# ADDENDUM NO. 3

### November 28, 2022

# JACKSON ELEMENTARY SCHOOL RENOVATIONS Valparaiso, IN 46304

This Addendum consists of page ADD 3-1 and attached Addendum No. 3 from Gibraltar Design dated November 23, 2022 and consisting of 7 pages and 42 drawings.

GIBRALTAR DESIGN SHEET A-102 В

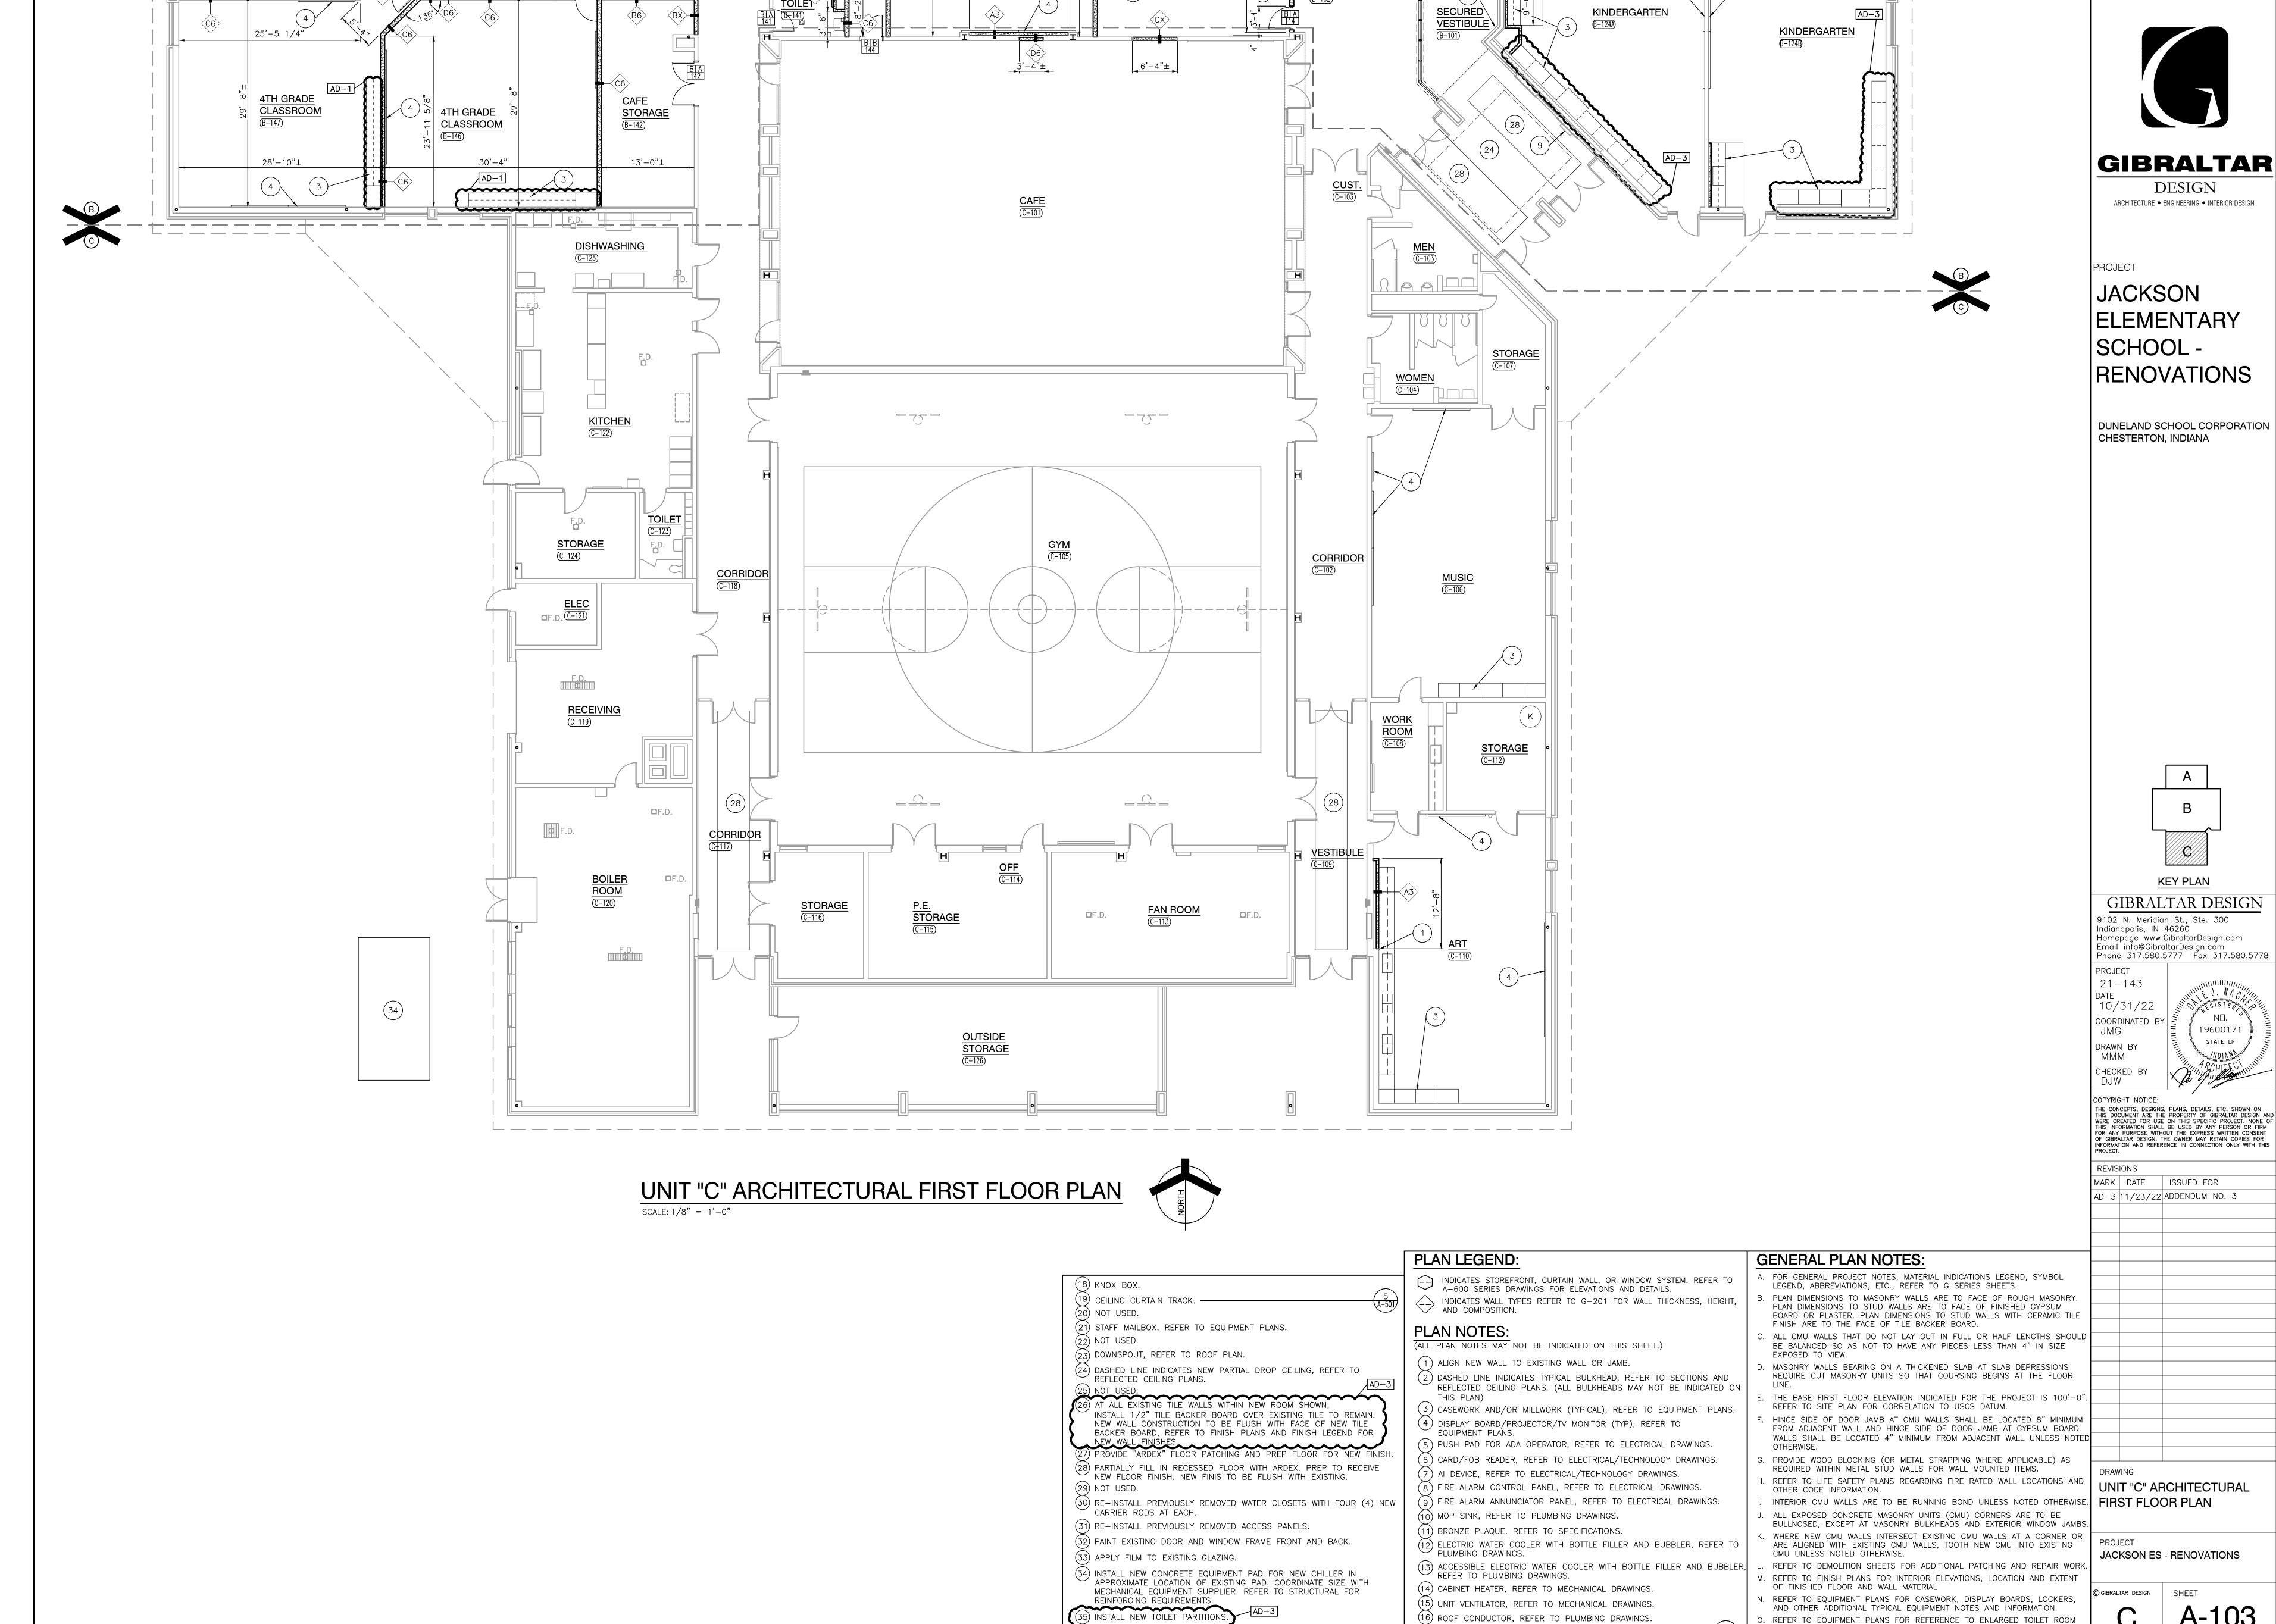
- A. Refer to revised full size drawing, included in this Addendum, for the following revisions:
  - 1. Revise Plan Note 26.
  - 2. Add Plan Note 35.
  - 3. Add Note 35 to Girls B-157 and Boys B-158.

A-103

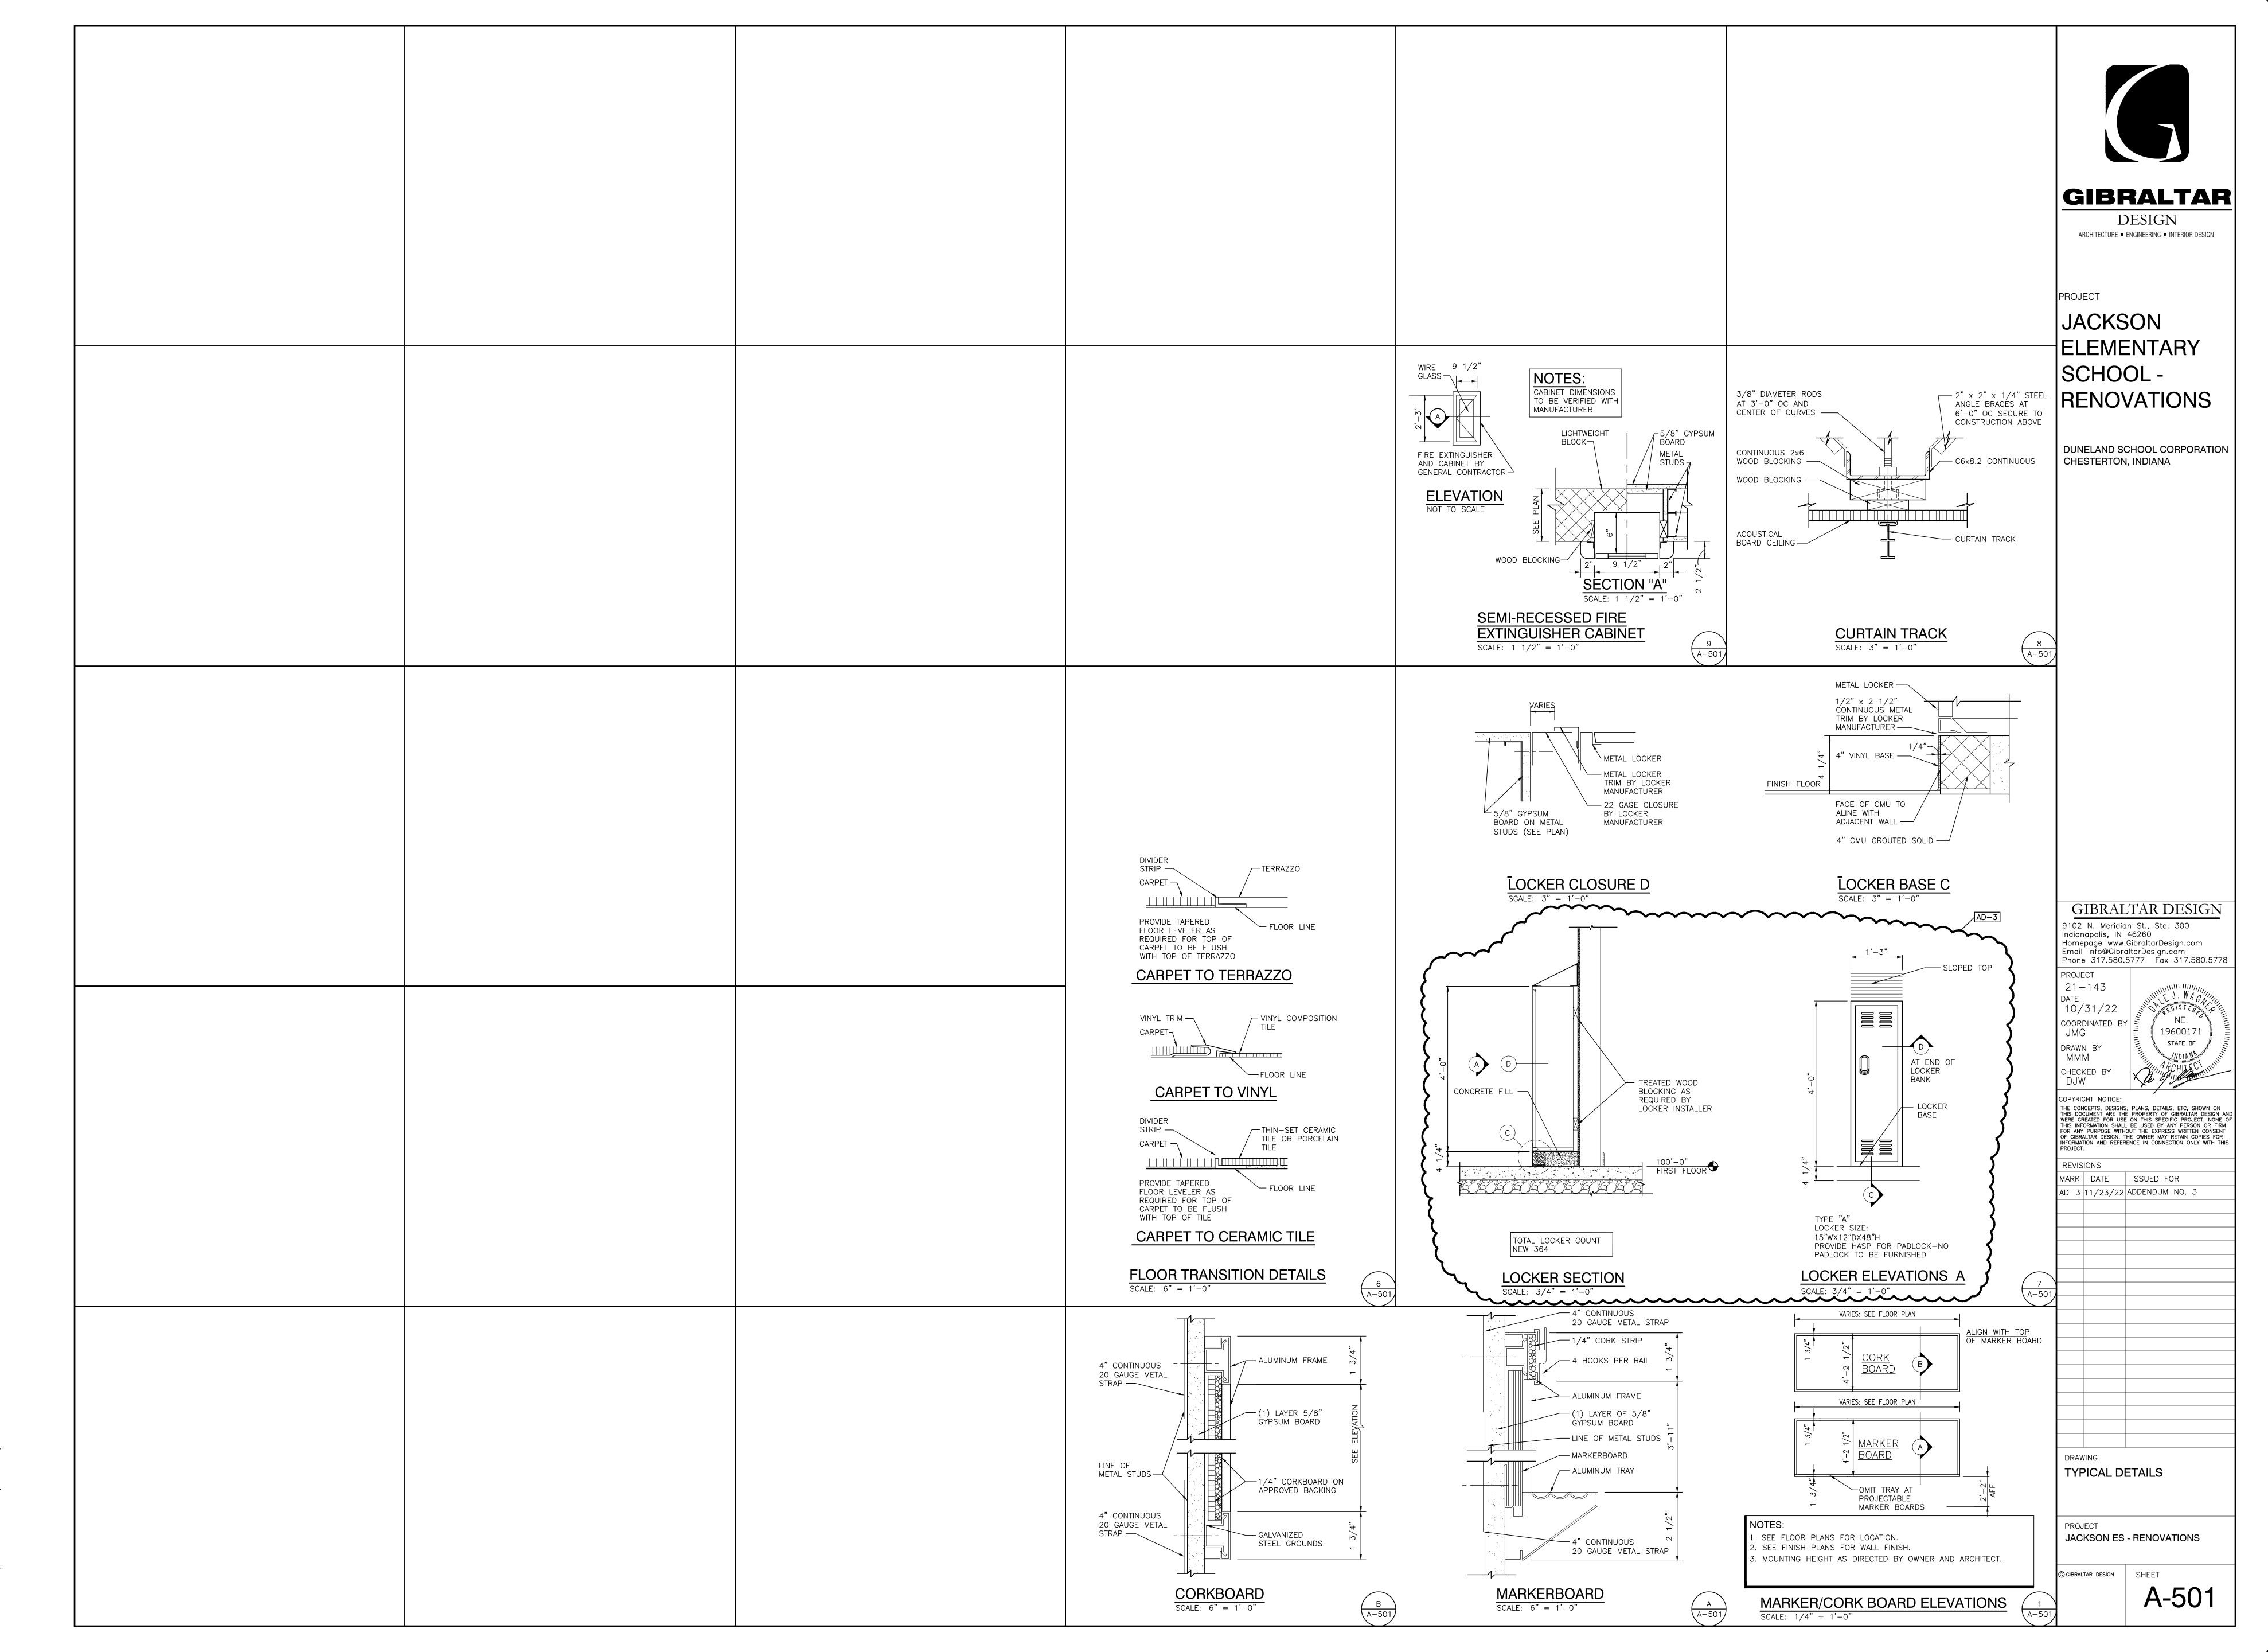
- A. Refer to revised full size drawing, included in this Addendum, for the following revisions:
  - 1. Revise Plan Note 26.
  - 2. Add Plan Note 35.

Wednesday, 11/23/2022 — 8:55 AM — LAST SAVED BY:JGRUE Y:\21—143 DUNELAND SC — JACKSON ES ADDITIONS AND RENOVATIONS\21—143 DRAWINGS\05 ARCH\A—401.DWG

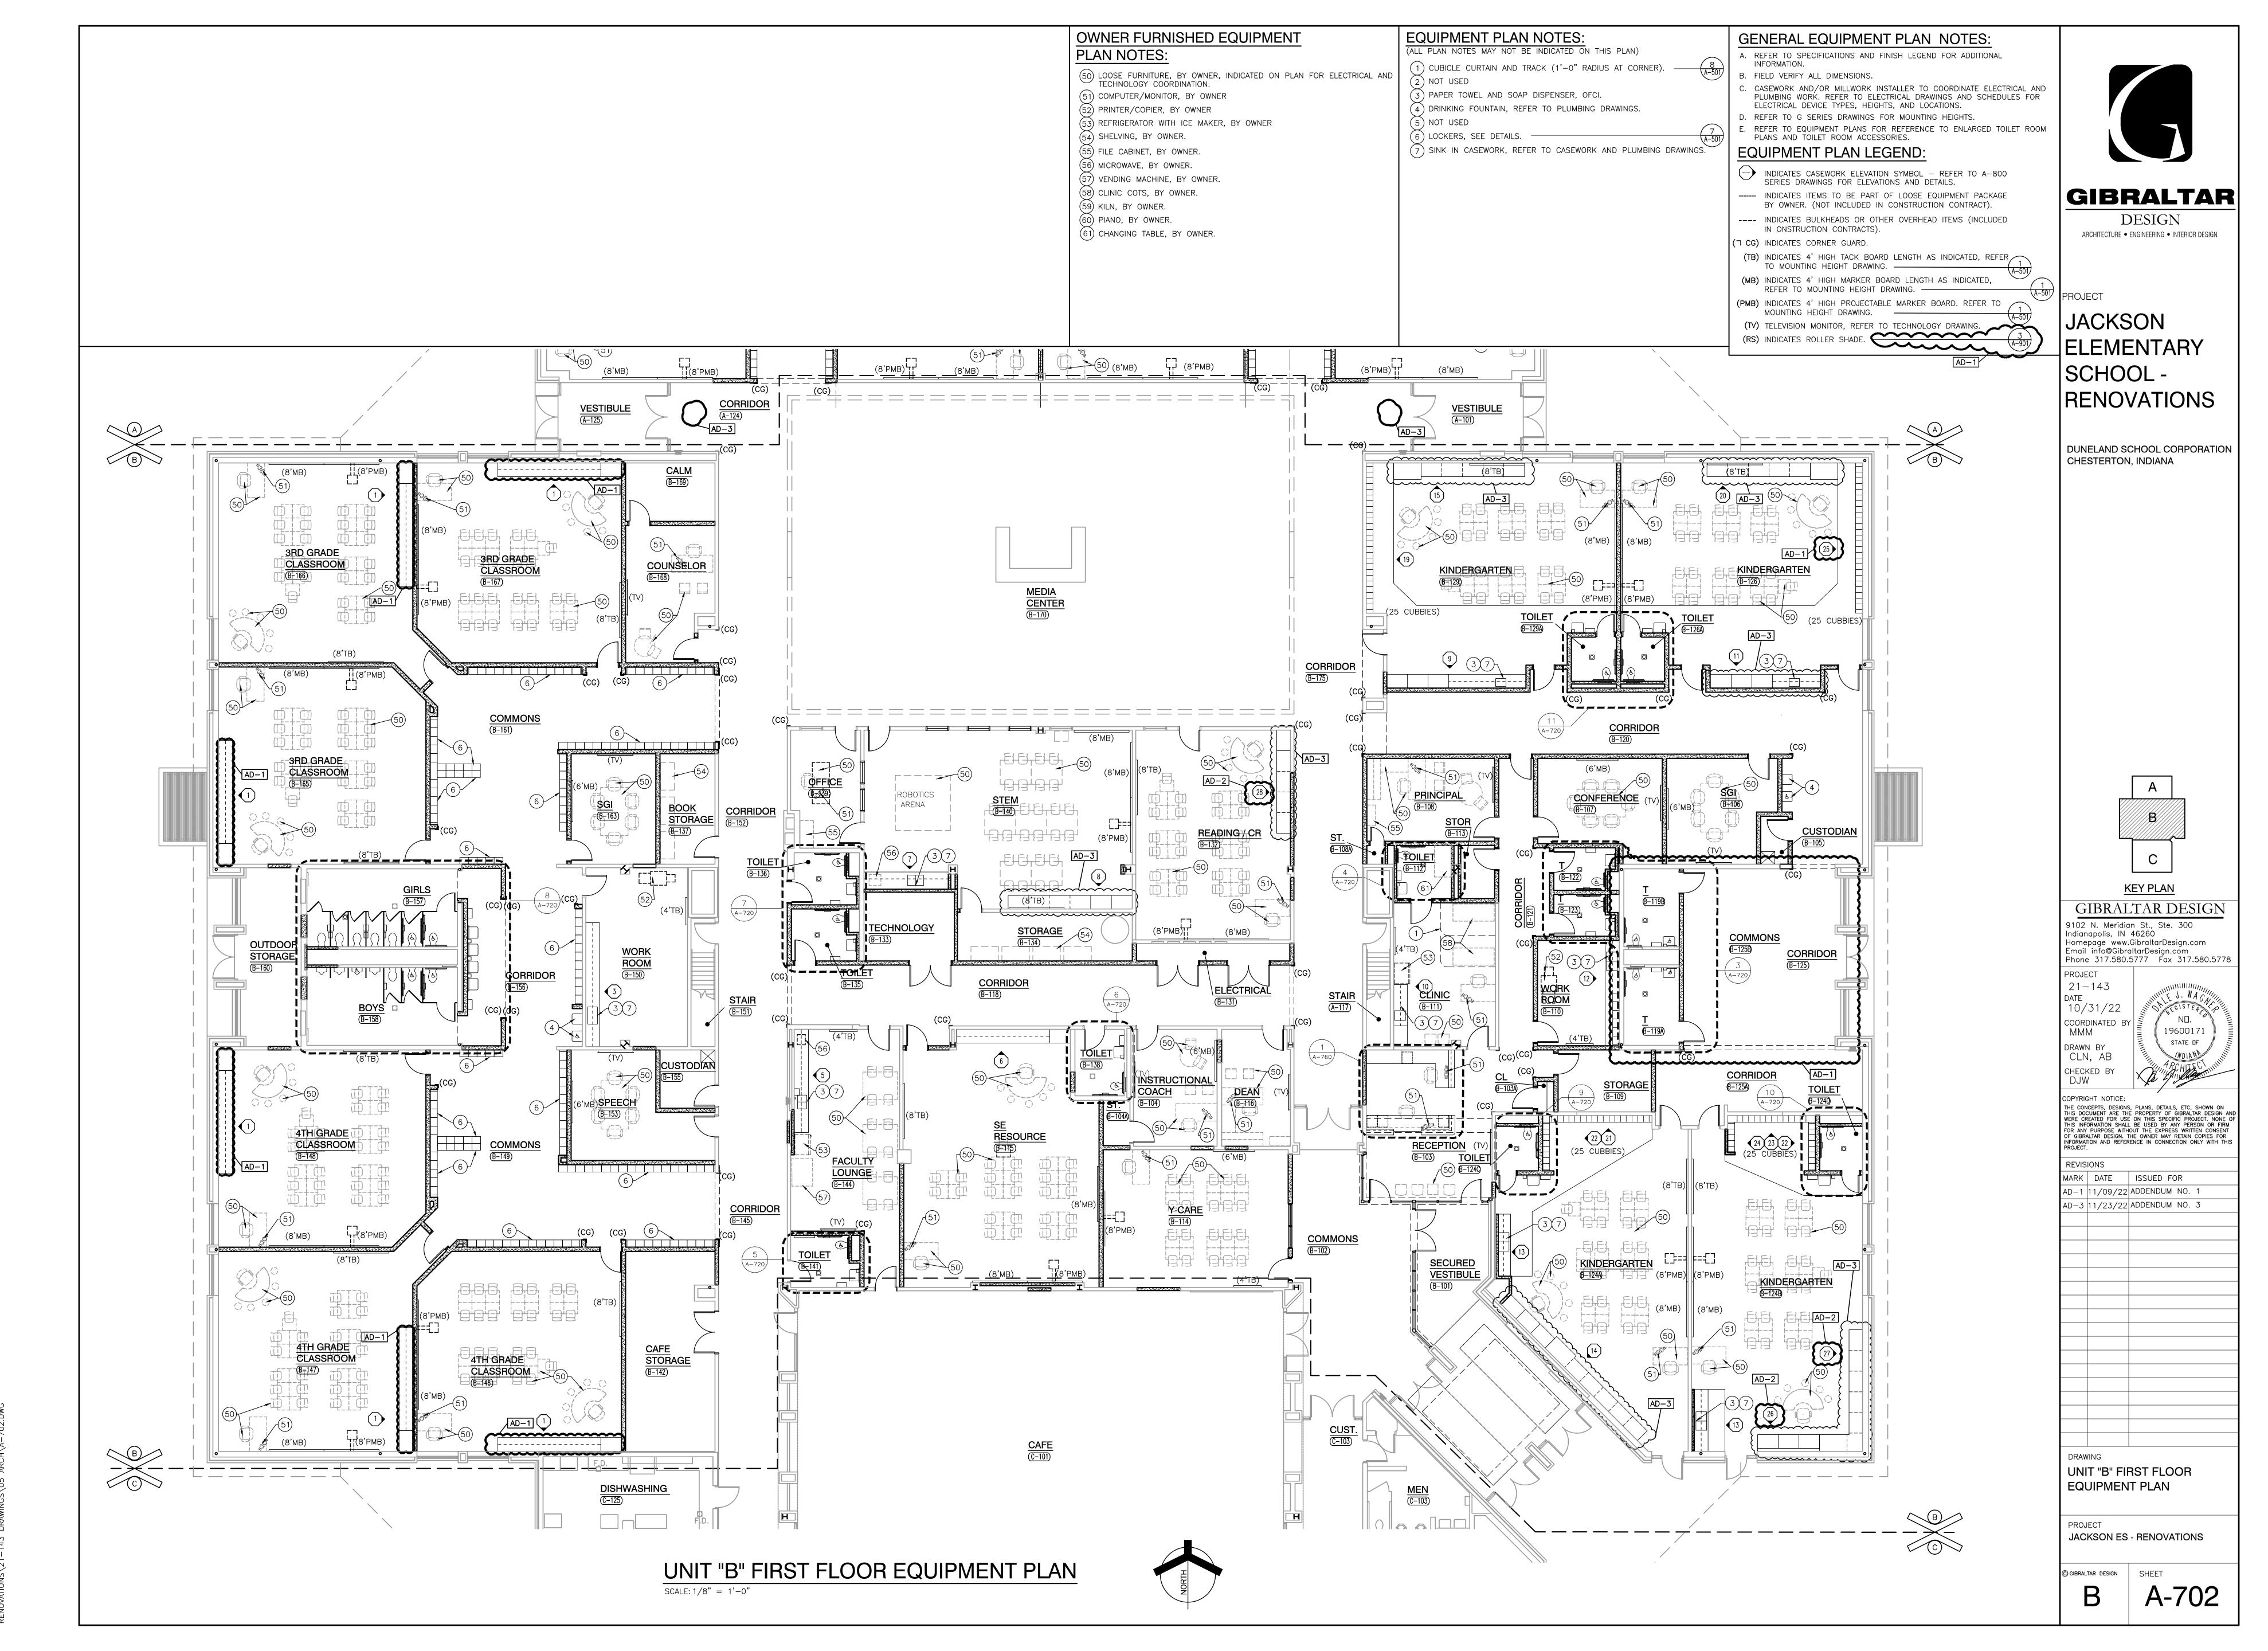
- A. Refer to revised full size drawing, included in this Addendum, for the following revisions:
  - 1. Wall Section 2/A-401: Add insulation between metal studs and aluminum window.
  - 2. Wall Section 2/A-401: Add dimension to clarify height of structural deck above ceiling.
